SUBJECT: DEMONSTRATION OF CONTAINMENT PURGE/VENT VALVE
OPERABILITY AND ITEM II.E.4.2.6 COMPLIANCE

Re: Duane Arnold Energy Center

SAFETY EVALUATION BY THE OFFICE OF NUCLEAR REACTOR REGULATION

DEMONSTRATION OF CONTAINMENT PURGE AND VENT VALVE OPERABILITY

Figure 3-2.2-3

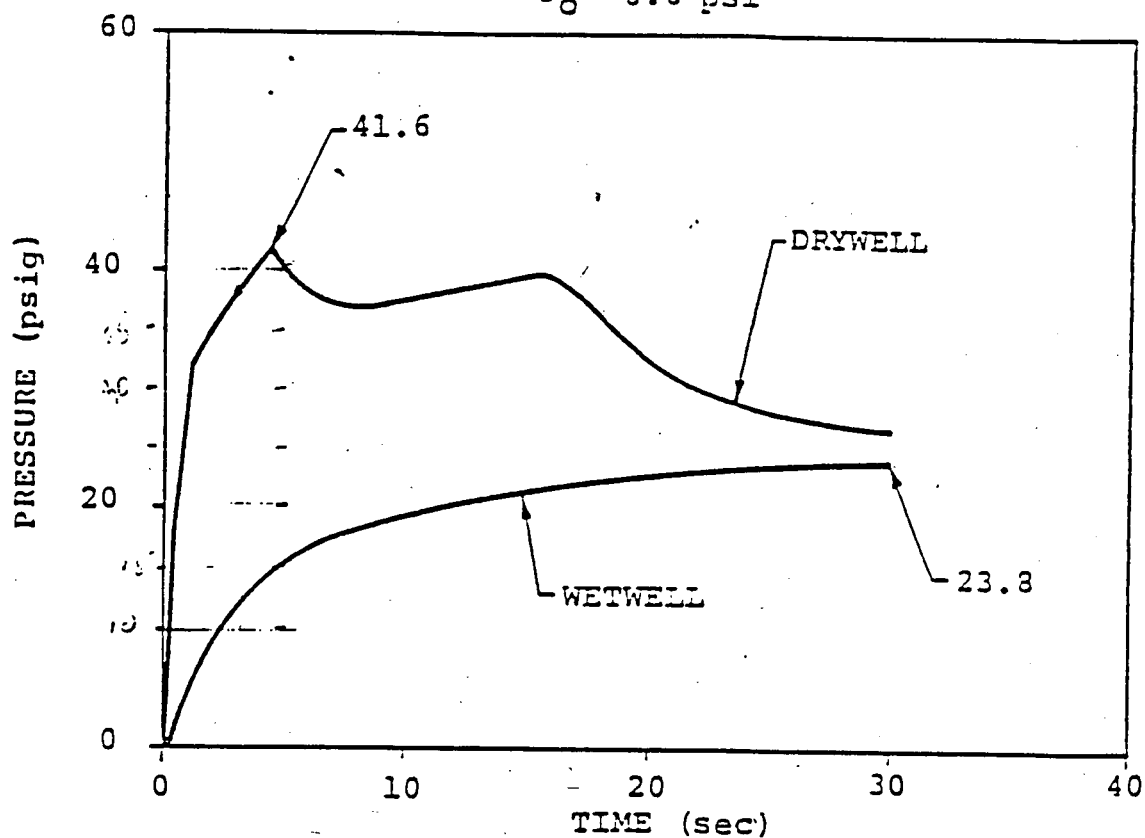
Additionally Reference J states that a recent analysis showed that the peak containment pressure resulting from a postulated LOCA will be less than 42 psi in the drywell and a wetwell pressure of 20 psi 10 seconds after initiation of the accident. A copy of the DBA/LOCA containment pressure response curve from the DAEC Plant Unique Analysis Report (PUAR) for the Mark I loads program was provided and is presented below.
